**TOWN OF GLASTONBURY
BID NO. GL-2018-14**

**HEBRON AVENUE PAVEMENT REHABILITATION
AND ROUNDABOUT AT HOUSE STREET**

**ADDENDUM NO. 1
FEBRUARY 6, 2018**

**INTERSECTION IMPROVEMENTS ANALYSIS PLAN
AT
HEBRON AVE & HOUSE STREET ROUNDABOUT
GLASTONBURY, CONNECTICUT**

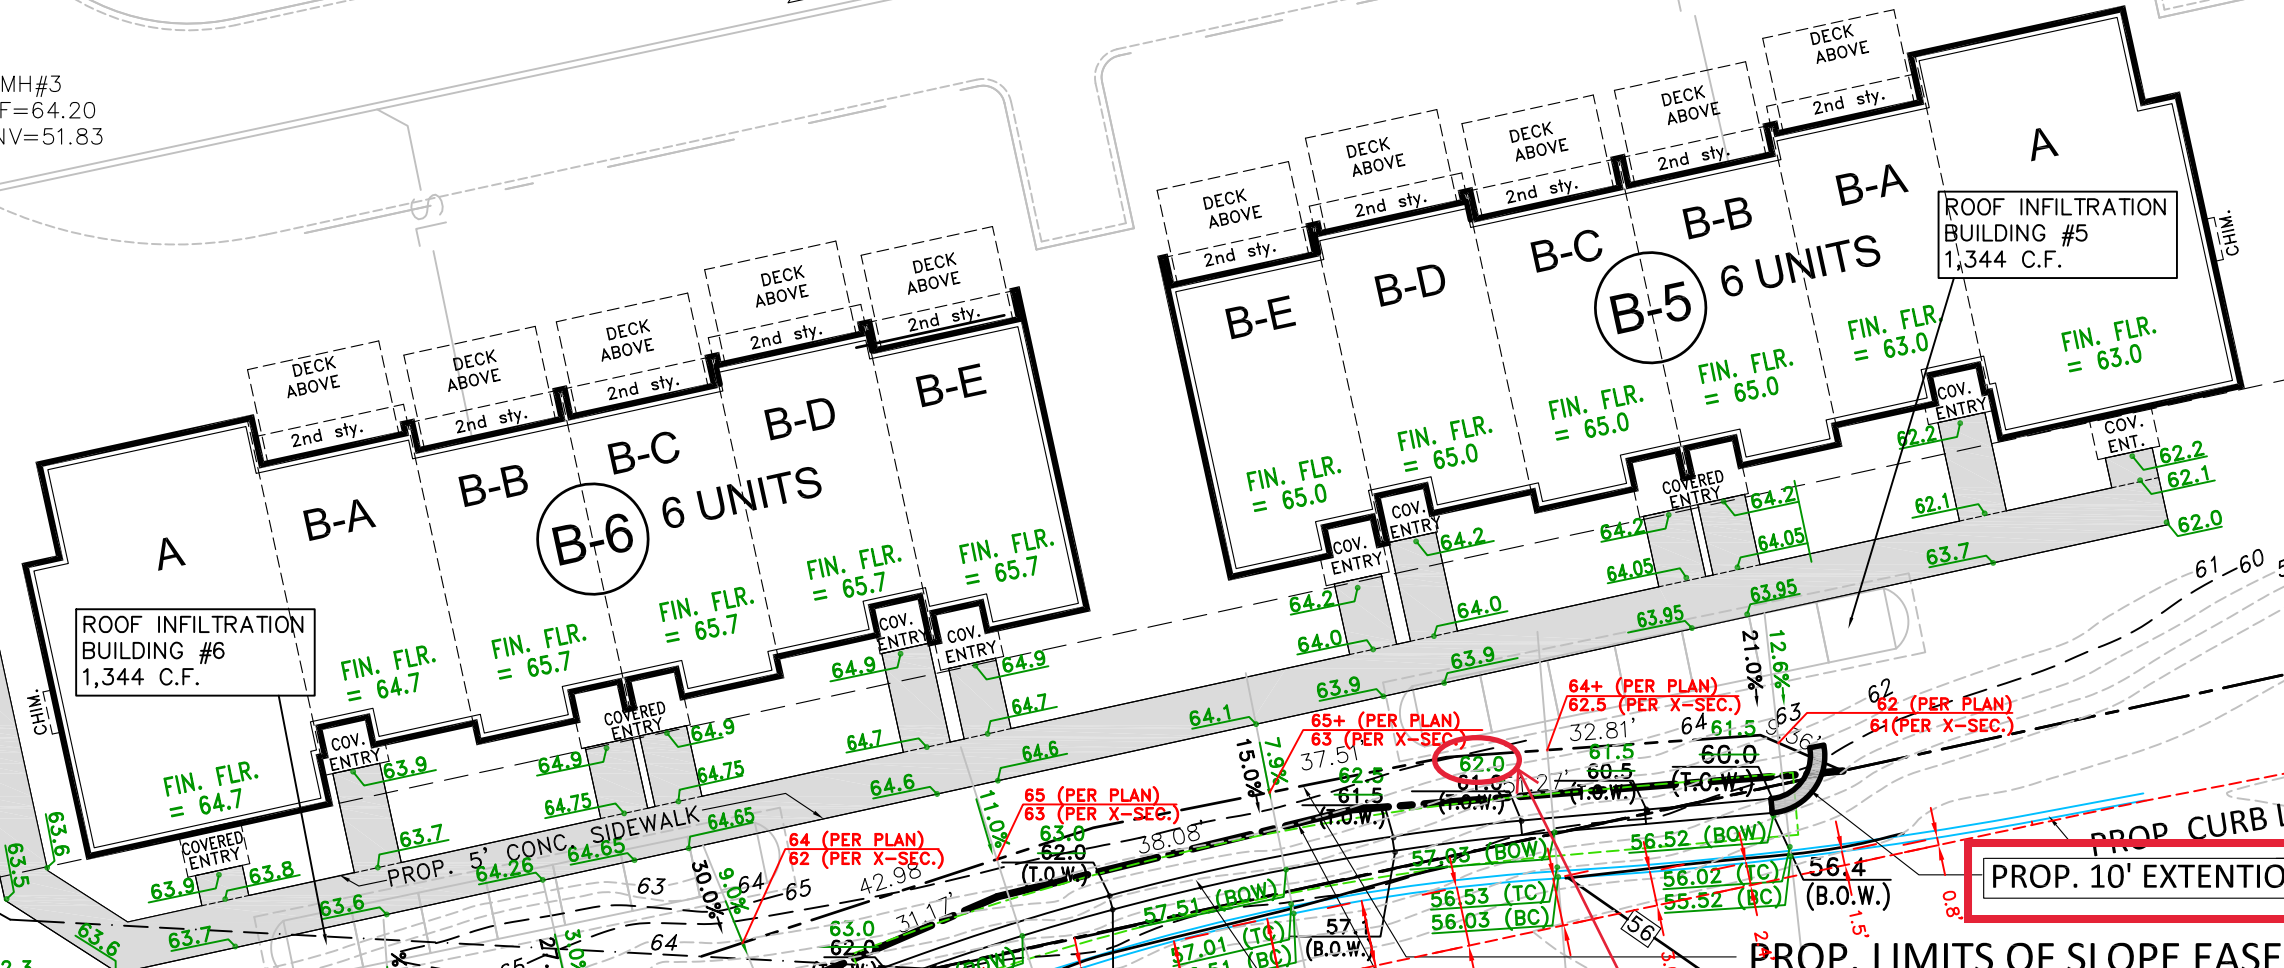
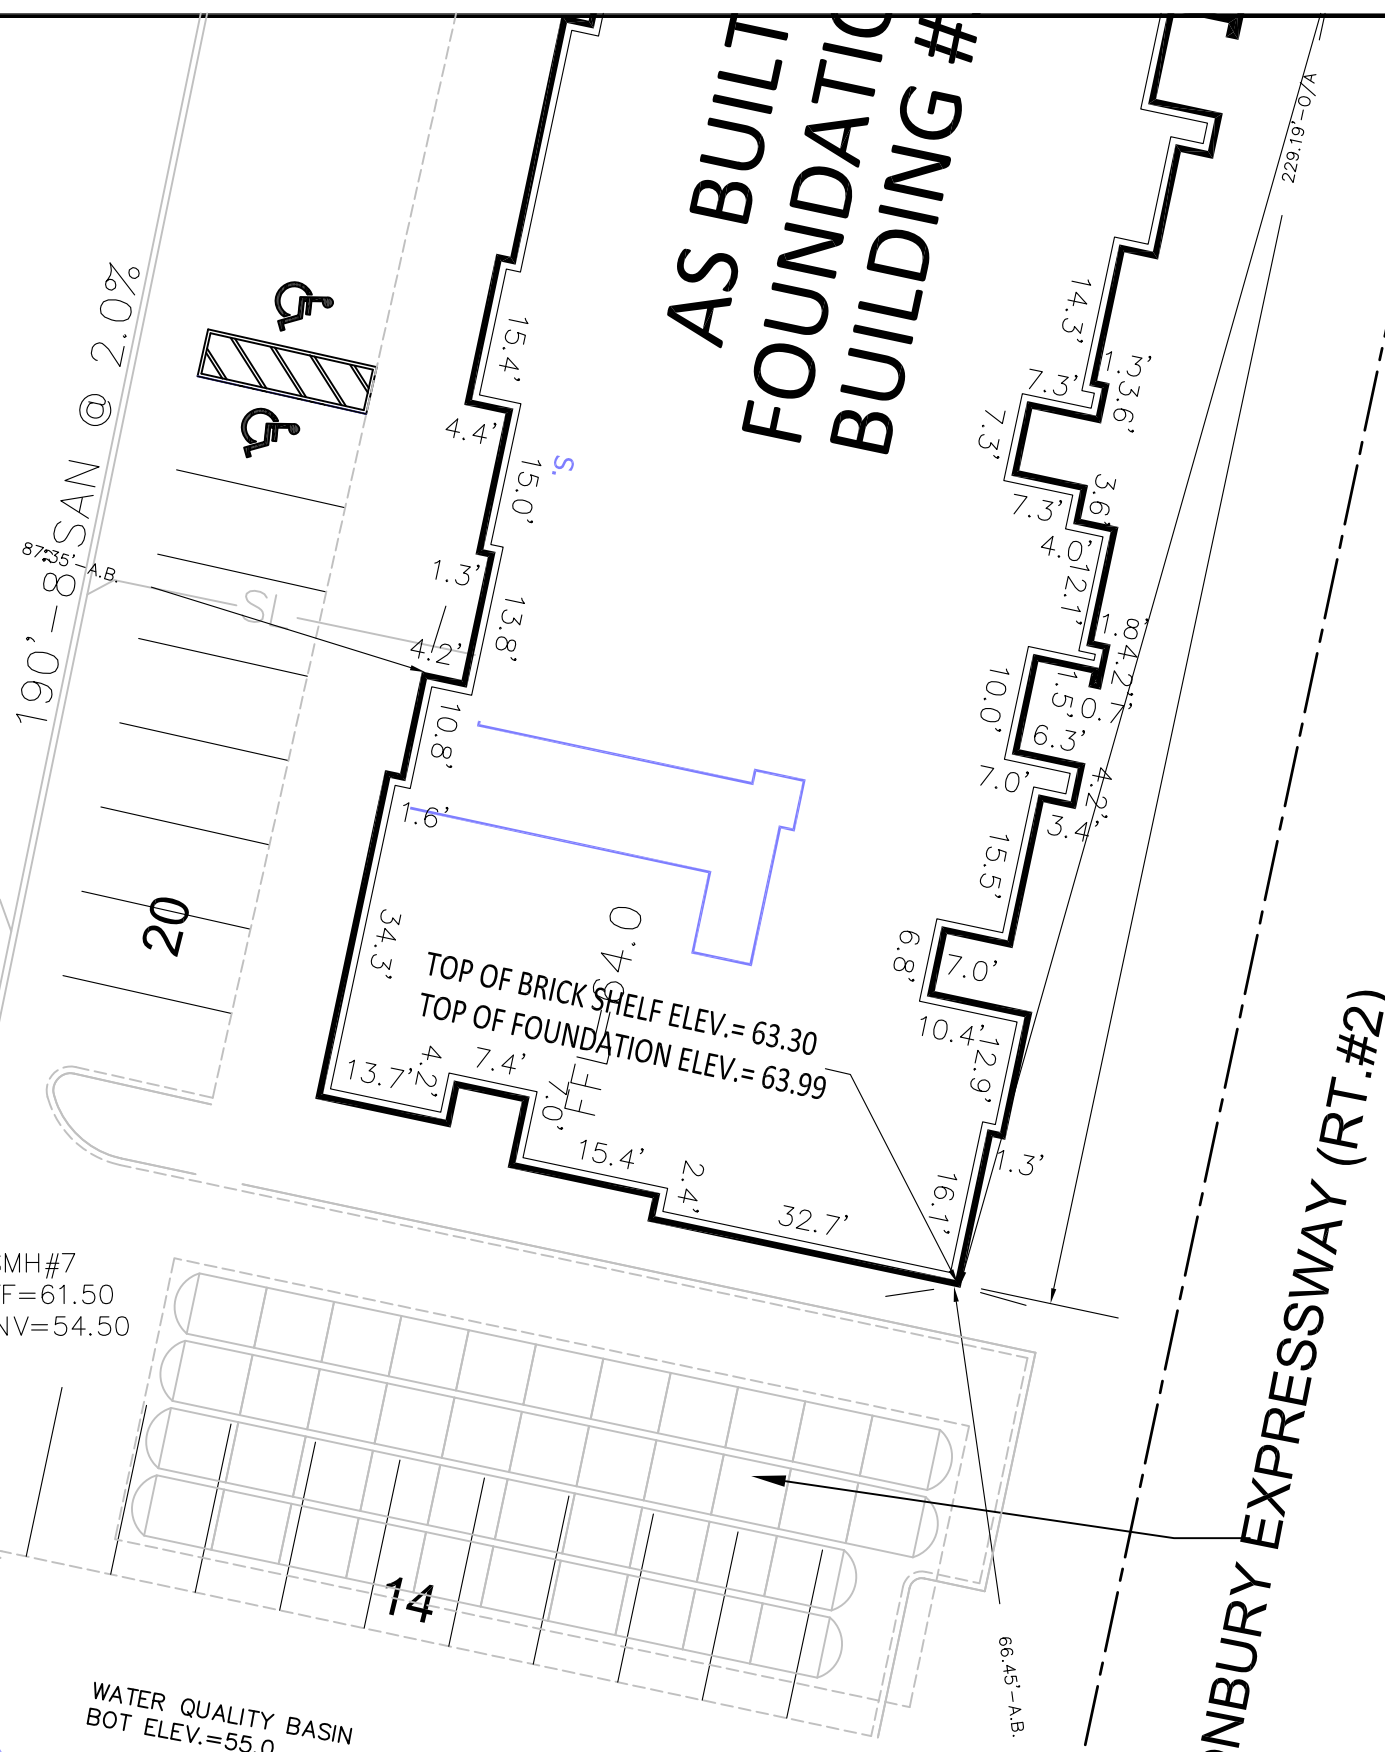
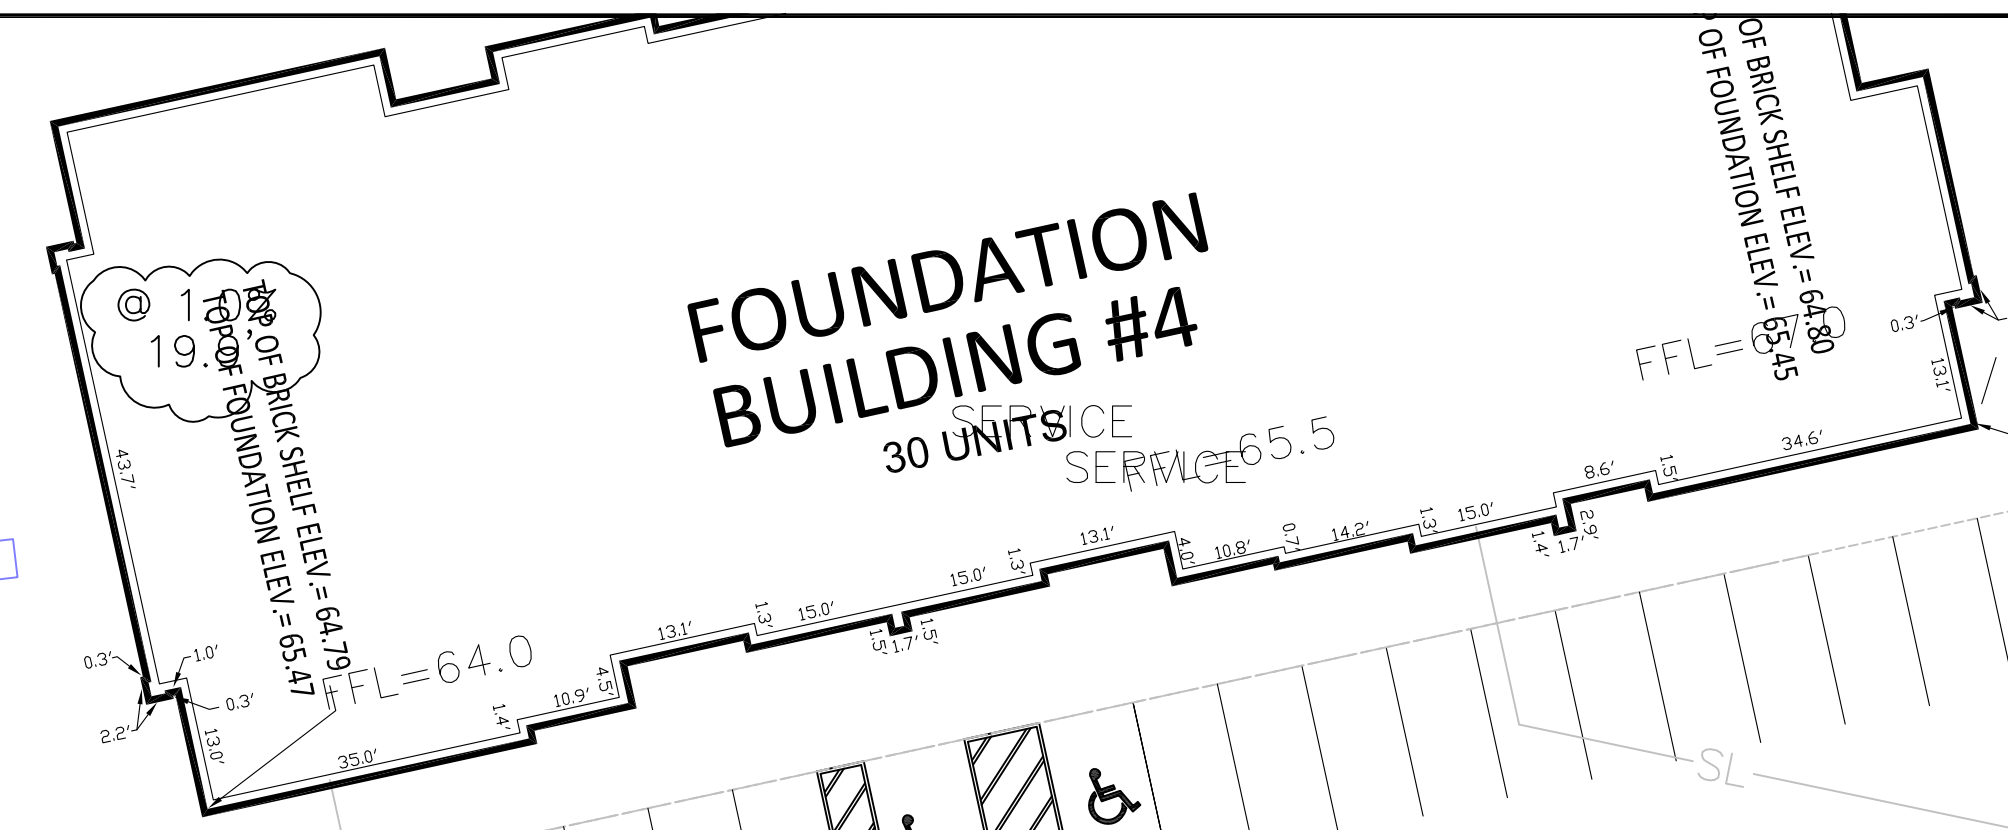
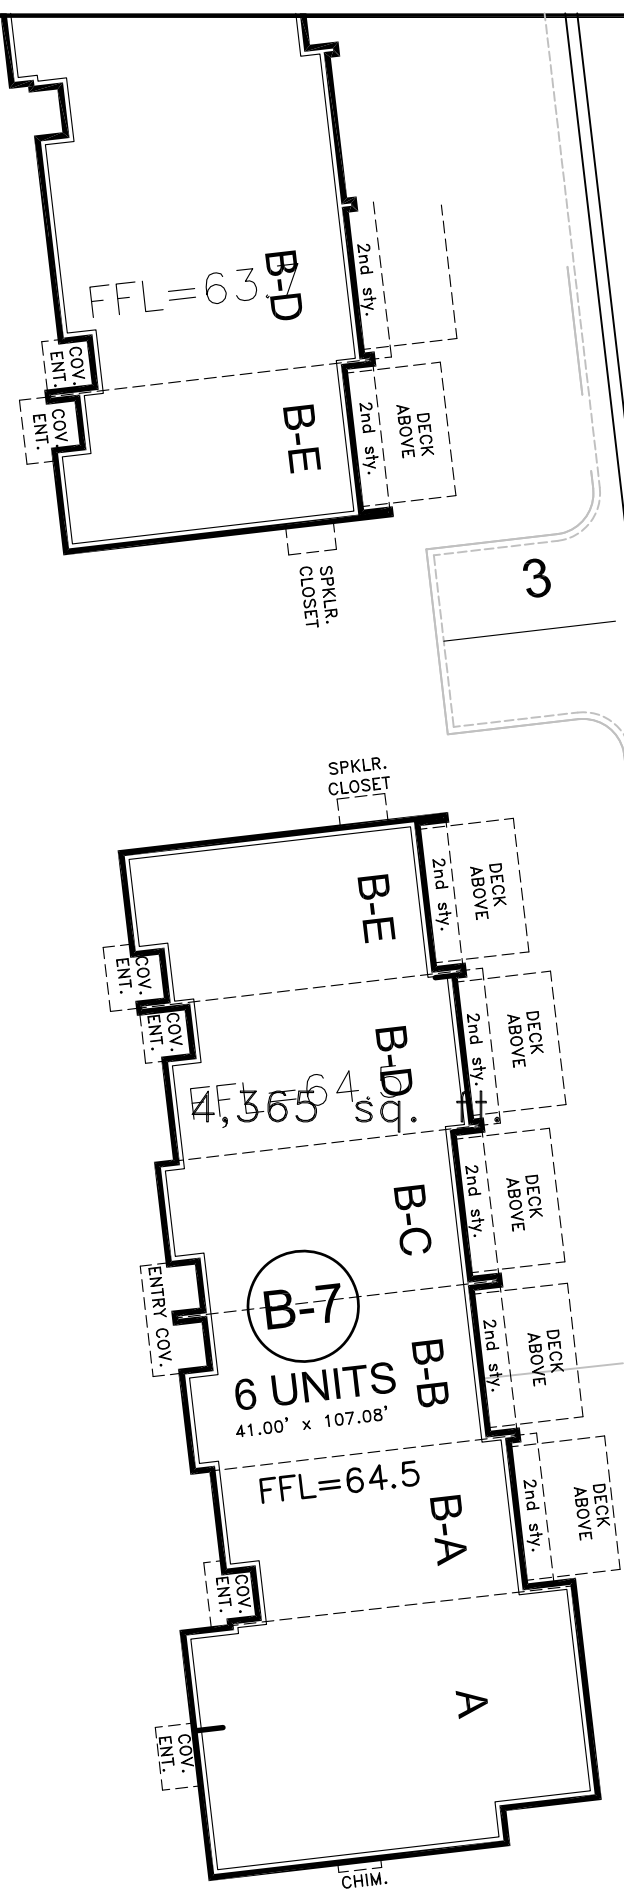
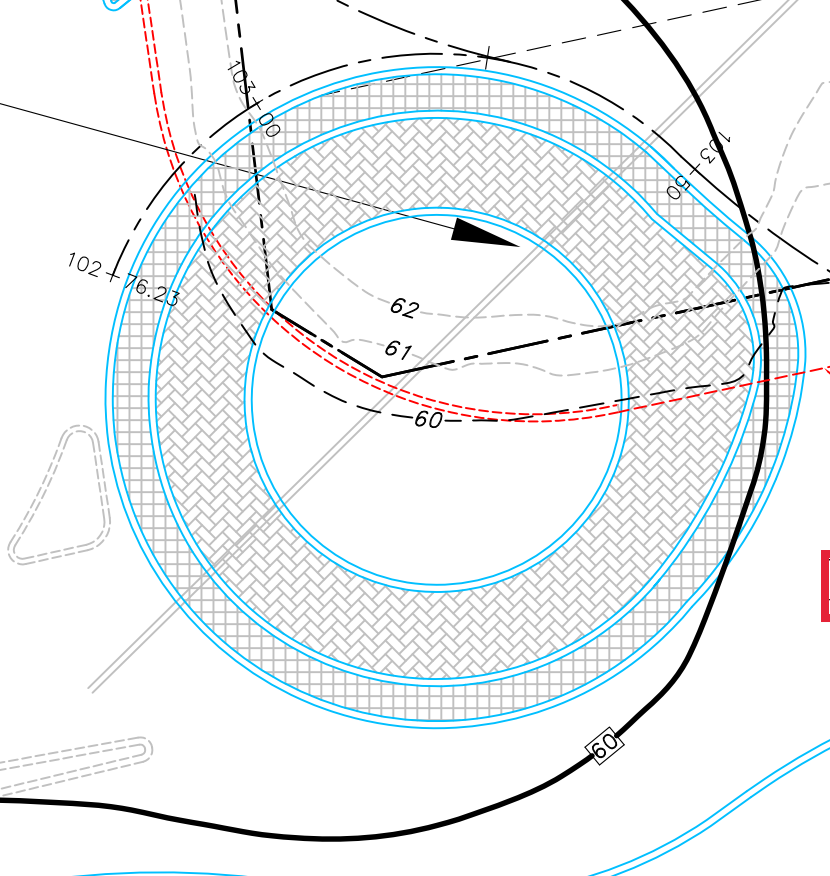
The plan entitled "Intersection Improvements Analysis Plan Hebron Avenue and House Street Roundabout at Glastonbury Mews" prepared by Hallisey, Pearson, and Cassidy Civil Engineers and Surveyors LLC, is attached to this addendum and is included as part of the contract as a reference for ITEM 0601446A ADDITIONAL EMBANKMENT WALL (SITE NO. 1) (NON-PARTICIPATING).

PROP. 102' EXTENSION OF RET. WALL

PROP. 10' EXTENSION OF RET. WALL RETURN

NOTE REVISED
TOP OF WALL
ELEVATION
SHOWN IN
GREEN
THROUGHOUT
LENGTH OF WALL
